Office Action Summary

10/563,660

DETAILED ACTION

FIG. 1

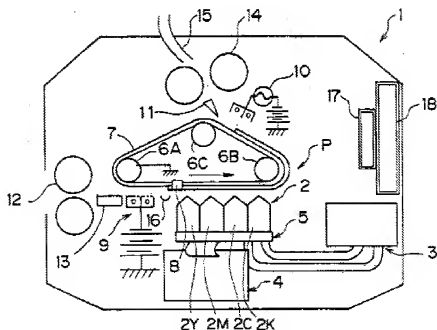
- b. As related to dependent **claim 2**, the combination of Nakazawa et al. and Koitabashi et al. remains as applied above and continues to teach discharging the first ink and second ink using a line head (Nakazawa et al. – Detailed Description, Paragraph 91).
- c. As related to independent **claim 4**, Nakazawa et al. teach an ink-jet printer (Nakazawa et al. – Title) in which recording is executed by discharging inks of a plurality of colors from a discharge opening as droplets of ink to be attached onto a recording material (Nakazawa et al. – Background, Paragraph 5; Summary, Paragraphs 8 & 11; Detailed Description, Paragraph 58 and Figure 1, Reference #2Y, #2M, #2C & #2K, shown below).

FIG. 47

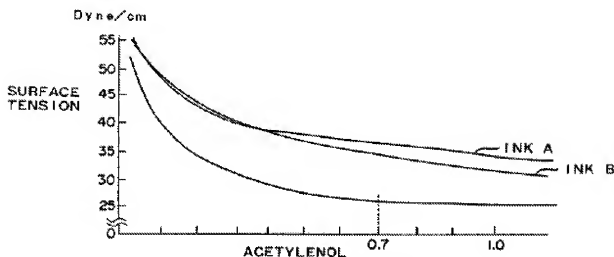
- a. As related to dependent **claim 3**, the combination of Nakazawa et al. and Koitabashi et al. teaches the limitation of **claim 1** for the reasons above. Additionally, Nakazawa et al. teaches a variety of recording material to include high quality papers, micro-coated papers, and dedicated inkjet papers (Nakazawa et al. – Detailed Description, Paragraph 137). Regarding the use of a specific recording material the claimed description of the print medium is merely nonfunctional descriptive material, not related to the actual recording method and it does not carry patentable weight. *However*, in an effort to further prosecution, Examiner recognizes Nakazawa et al. teaches a variety of recording material can be used, which would include the recording medium with the claimed features. *Additionally*, Koitabashi et al. ('691) teaches use of recording material having an ink absorption amount in 100mS between 15mL/m² and 99 mL/m² [i.e. 10-50 mL/m² for Semi-penetrative ink and 50+ mL/m² for high-penetrative ink] (Koitabashi et al. – Title; Abstract; Summary, Column 3, Lines 1-20; Detailed Description, Column 10, Line 64 – Column 11, Line 36; Table 1; and Figure 47, both shown below).

in an effort to further prosecution, Examiner recognizes Nakazawa et al. teaches a variety of recording material can be used, which would include the recording medium with the claimed features. *Additionally*, Koitabashi et al. ('691) teaches use of recording material having an ink absorption amount in 100mS between 15mL/m^2 $\{18\text{mL/m}^2\}$ and 40mL/m^2 [i.e. $10\text{-}50\text{ mL/m}^2$ for Semi-penetrative ink] (Koitabashi et al. – Title; Abstract; Summary, Column 3, Lines 1-20; Detailed Description, Column 10, Line 64 – Column 11, Line 36; Table 1; and Figure 47, both shown above).

FIG. 47

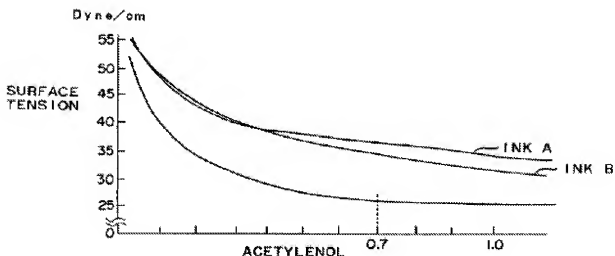
Description, Paragraph 137). Examiner recognizes Nakazawa et al. teaches a variety of recording material can be used, which would include the recording medium with the claimed features. **Additionally**, Koitabashi et al. ('691) teaches use of recording material having an ink absorption amount in 100mS between 15mL/m² and 99 mL/m² [i.e. 10-50 mL/m² for Semi-penetrative ink and 50+ mL/m² for high-penetrative ink] (Koitabashi et al. – Title; Abstract; Summary, Column 3, Lines 1-20; Detailed Description, Column 10, Line 64 – Column 11, Line 36; Table 1; and Figure 47, both shown below).

d. As related to dependent **claims 8 & 10**, the combination of Nakazawa et al. and Koitabashi et al. teaches the limitation of **claim 4** for the reasons above. Additionally, Nakazawa et al. teaches a variety of recording material to include high quality papers, micro-coated papers, and dedicated inkjet papers (Nakazawa et al. – Detailed Description, Paragraph 137). Examiner recognizes Nakazawa et al. teaches a variety of recording material can be used, which would include the recording medium with the claimed features. *Additionally*, Koitabashi et al. ('691) teaches use of recording material having an ink absorption amount in 100mS between 15mL/m^2 $\{18\text{mL/m}^2\}$ and 40 mL/m^2 [i.e. $10\text{-}50\text{ mL/m}^2$ for Semi-penetrative ink] (Koitabashi et al. – Title; Abstract; Summary, Column 3, Lines 1-20; Detailed Description, Column 10, Line 64 – Column 11, Line 36; Table 1; and Figure 47, both shown above).
